FINAL DRAINAGE REPORT

GRANDVIEW RESERVE FILING NO. 1

El Paso County, Colorado

DATE:
October 14, 2022

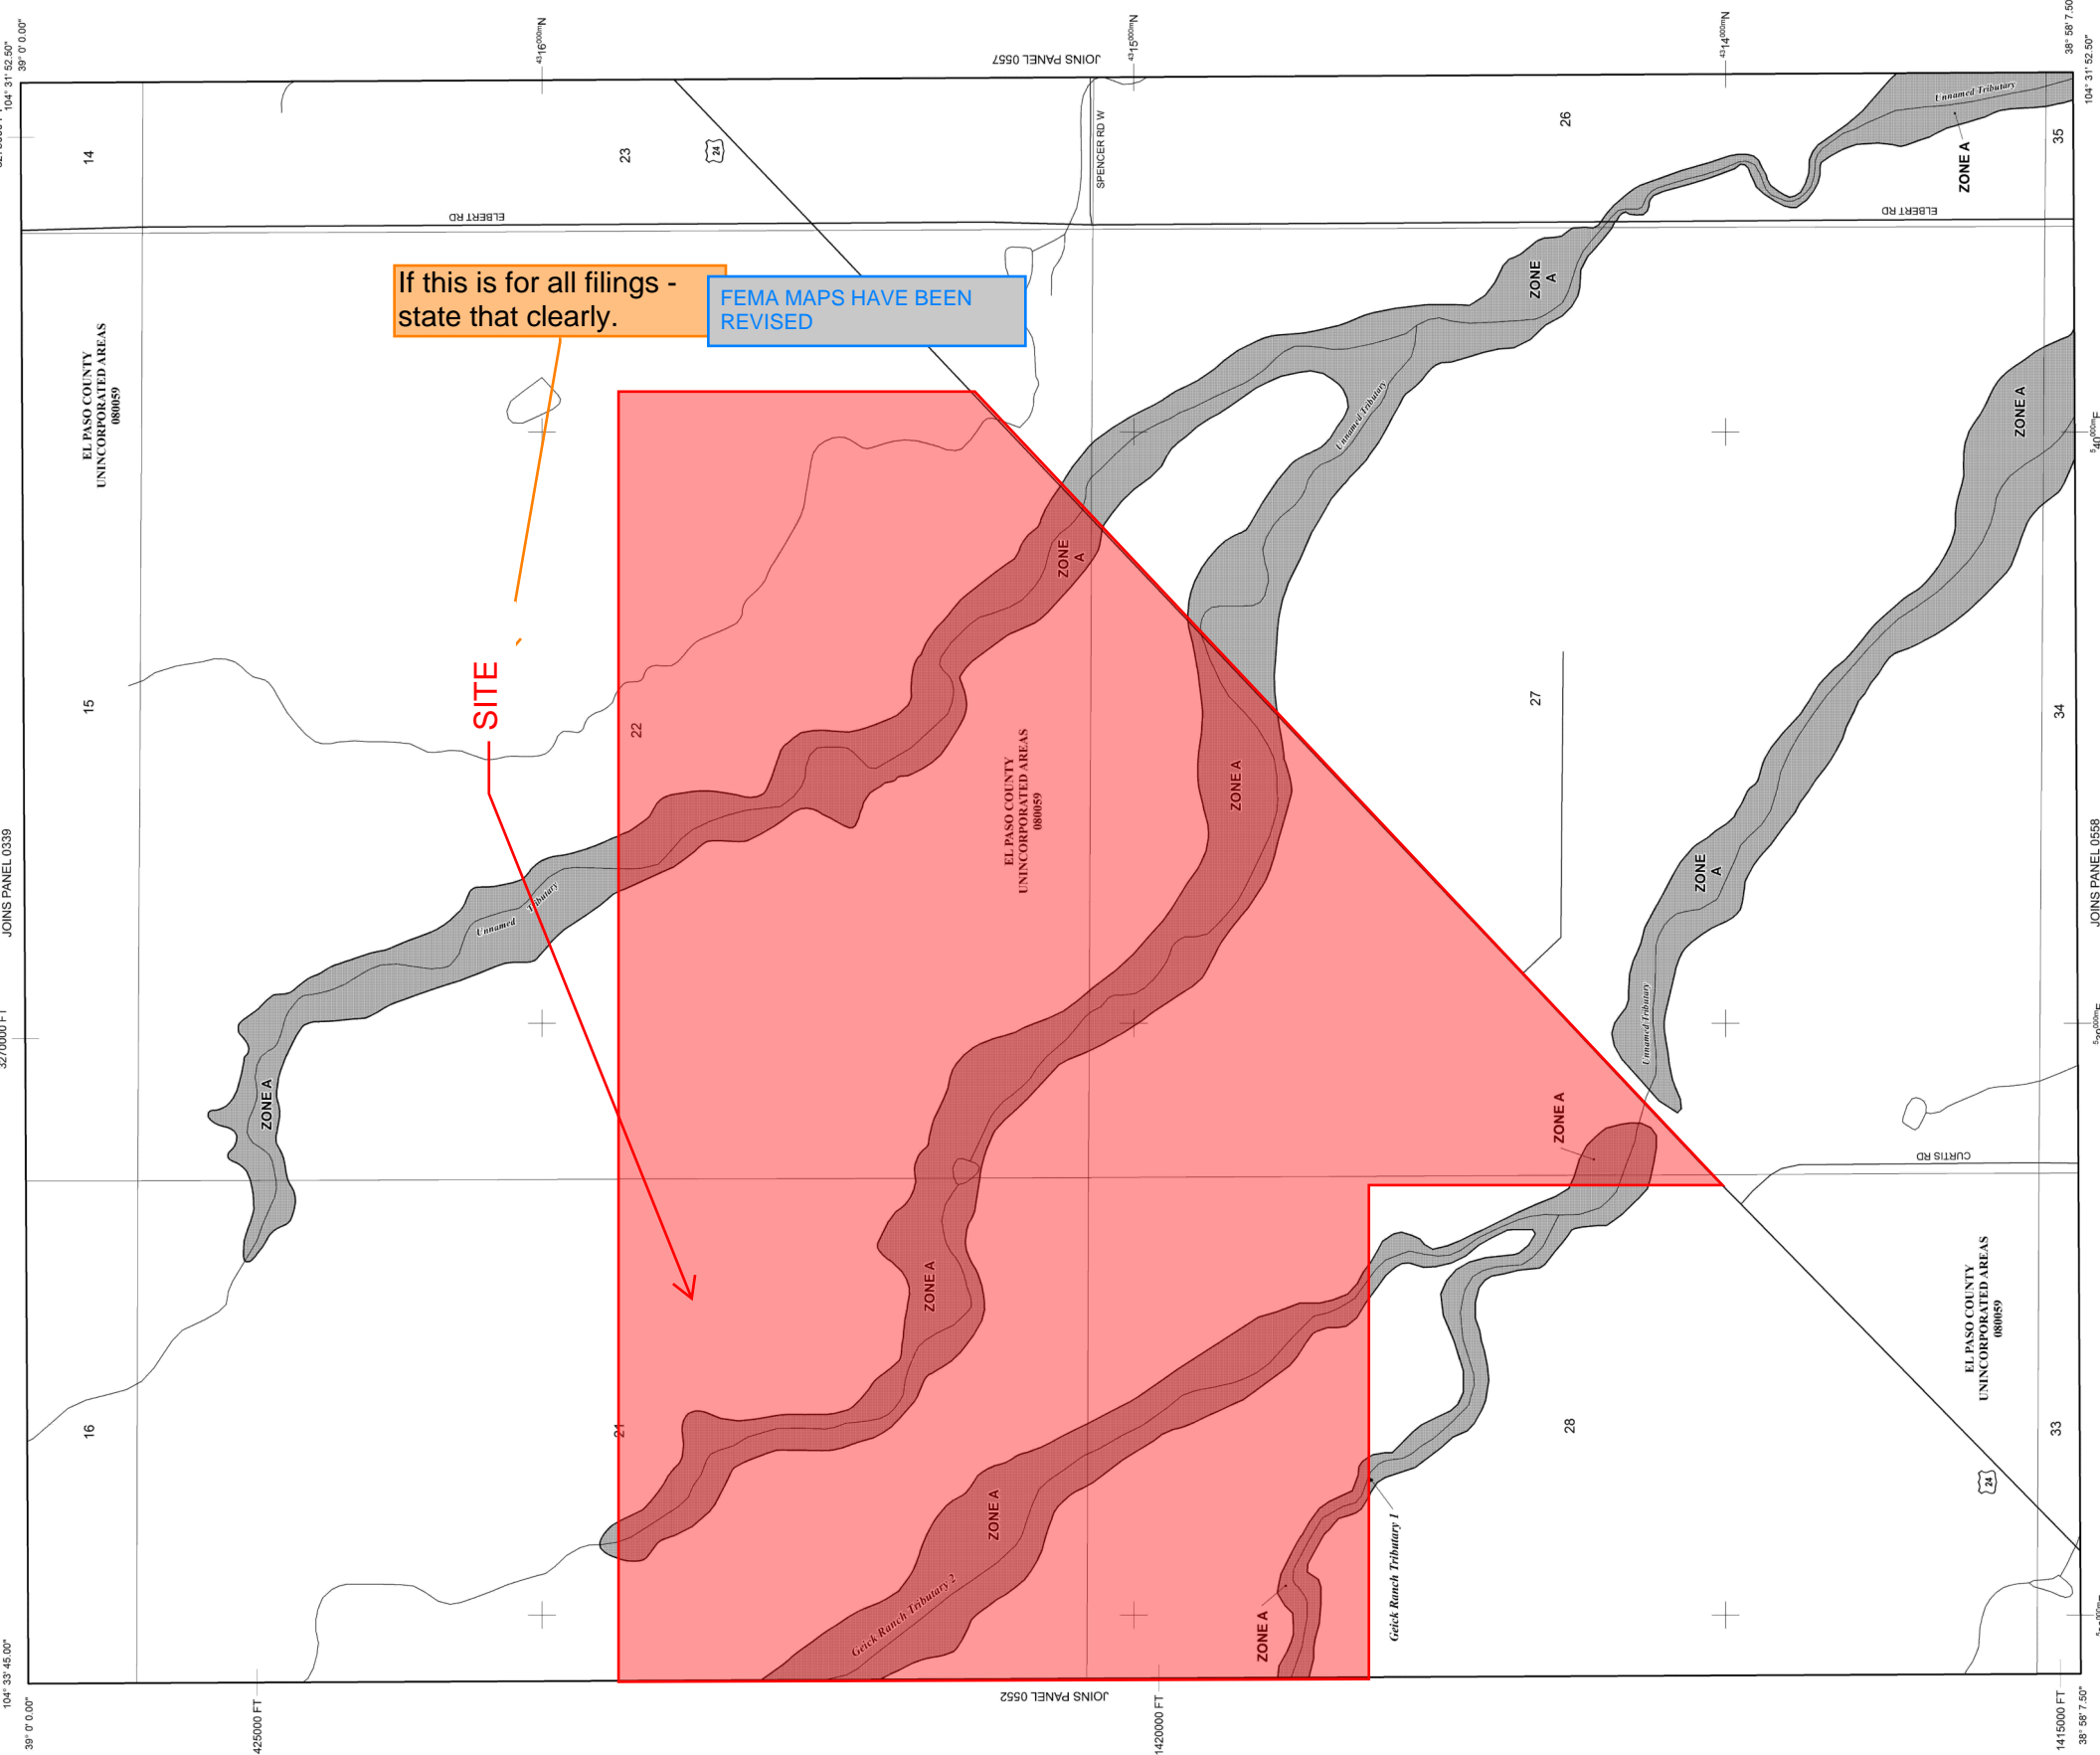
If this is for all filings - state that clearly.

FEMA MAPS HAVE BEEN REVISED

Basin D-7b Swale

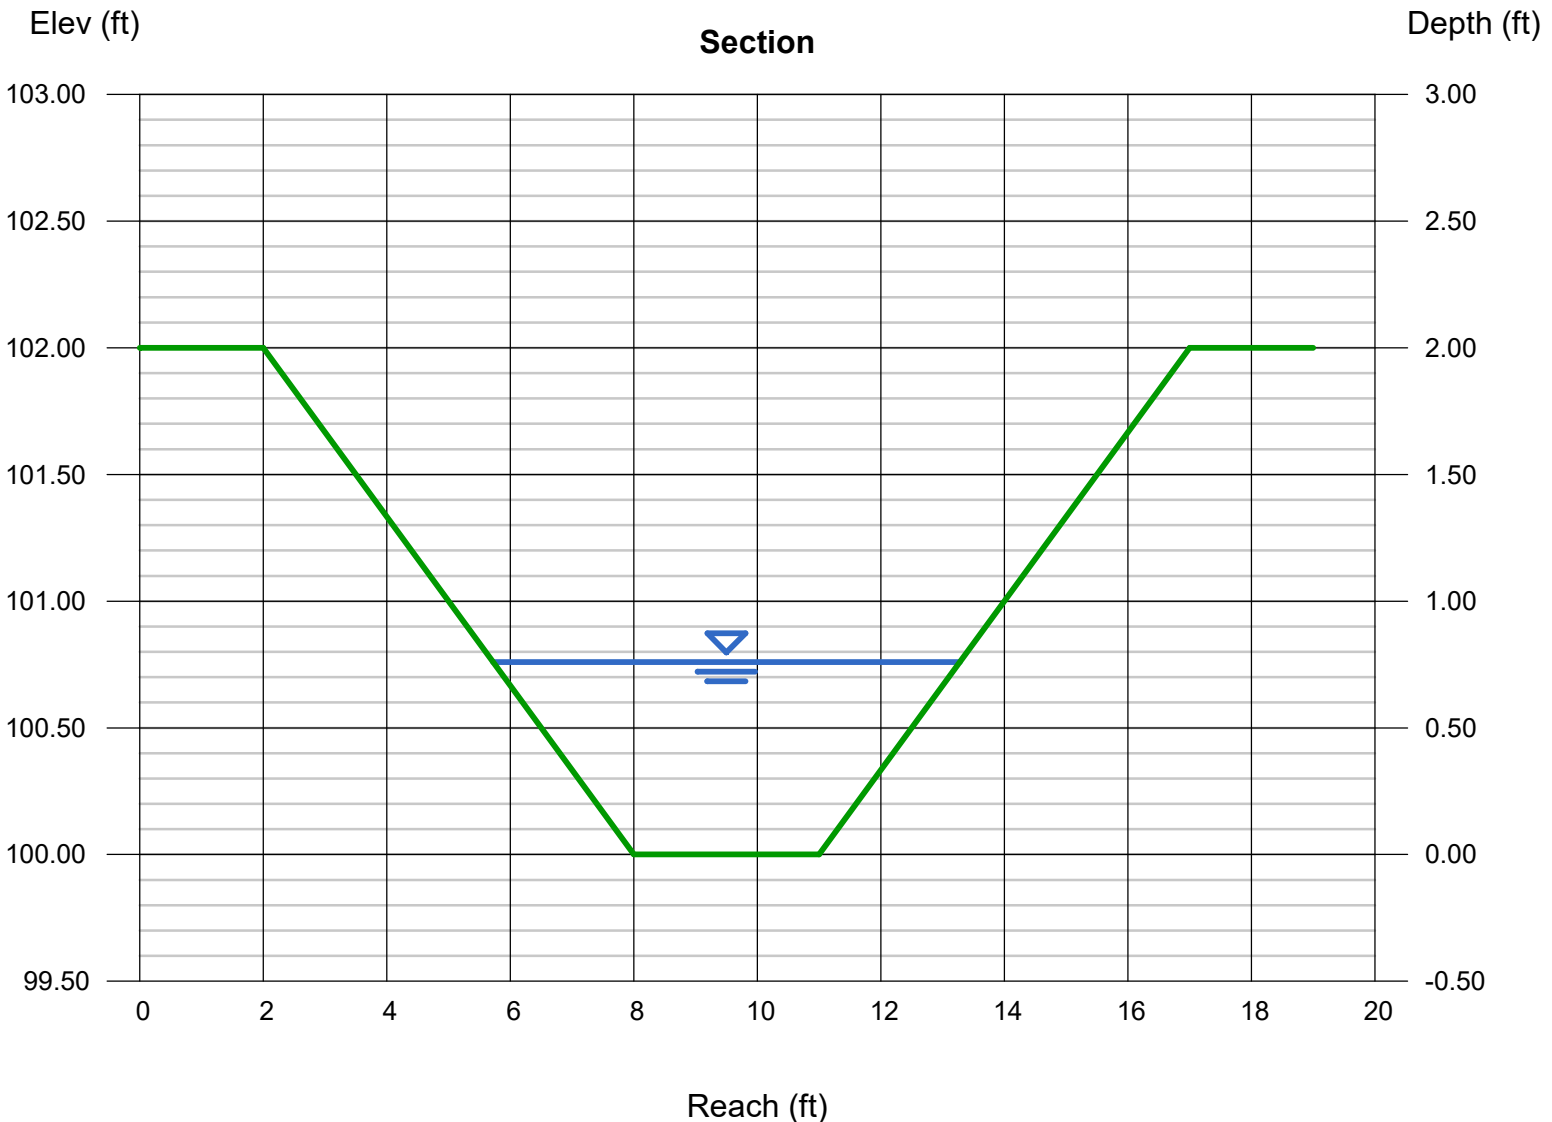
Due to velocity, swale will need to be lined

REVISED

Calculations

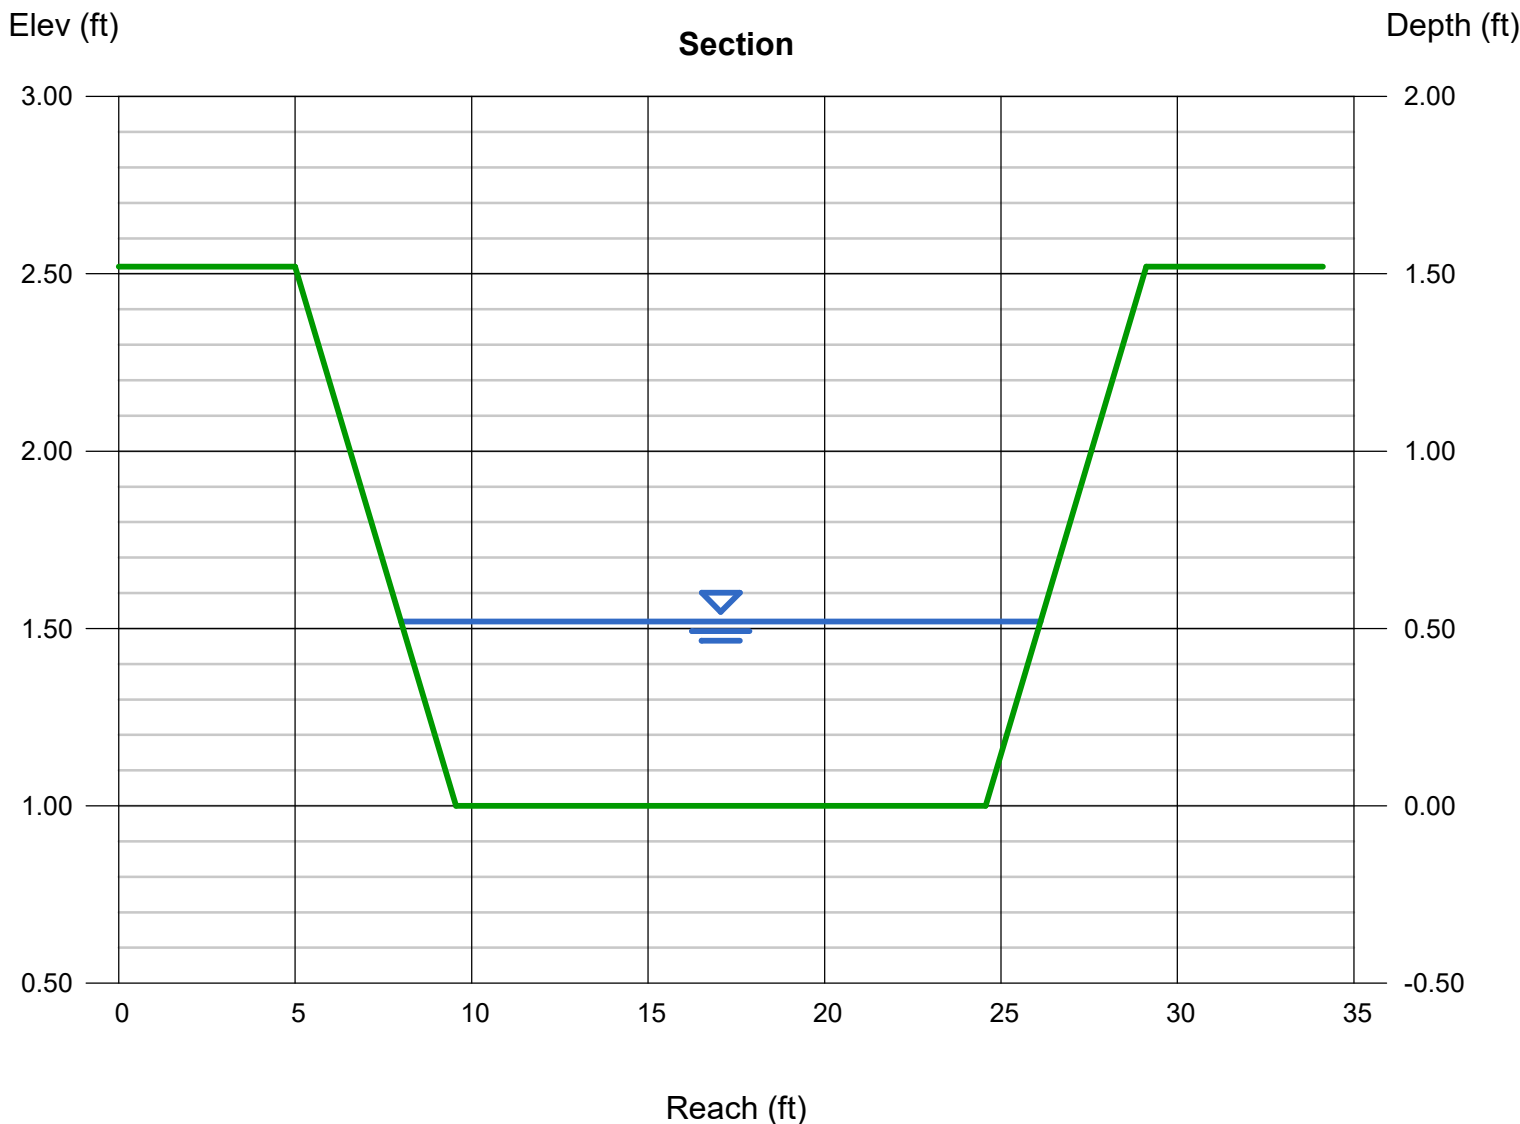
Why is n-value so low?
Discuss within report.

REVISED
